COMMENT FORM

California American Water Company (Cal Am) Monterey Peninsula Water Supply Project Draft Environmental Impact Report

Inappropriate Determination of Existing Water Demand

WHAT THIS GRAPH TELLS US

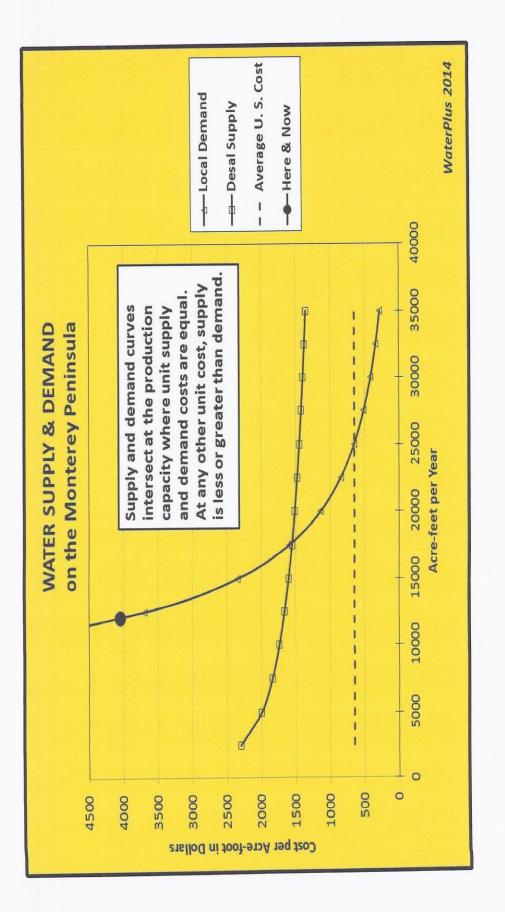
The determination of existing local water demand in <u>Section 2.3.1</u> is simply an average of local annual water usage over a five-year period from 2007 to 2011. This period is a time of reduced water usage because of conservation pressures growing at an accelerating pace since the state's Order 95-10 and especially since the introduction of the tiered rate structure. Earlier annual usage tended to be closer to 17,000 to 18,000 acre-feet per year than the 13,291 acre-foot average used to determine existing demand in the DEIR.

Economists have developed a more accurate method of determining demand that takes cost and supply, as well as demand, into account. All these variables are inter-related, and to omit anyone of them from a demand determination would likely lead to an inaccurate result, though perhaps a politically palatable one. The EIR should use a supply-demand graph like the one attached to determine true existing water demand.

According to this graph, prepared by me, that demand is about 17,500 acrefeet per year, closer to the long-term average and what the more recent average might be in the absence of cost and political pressures.

REMEDIATION. To assure accuracy in the determination of existing demand, the EIR should require the applicant to have a competent economist develop a supply-demand curve to determine local existing water demand. Otherwise, the desalination plant built would very likely provide an insufficient supply of water to meet true existing local demand.
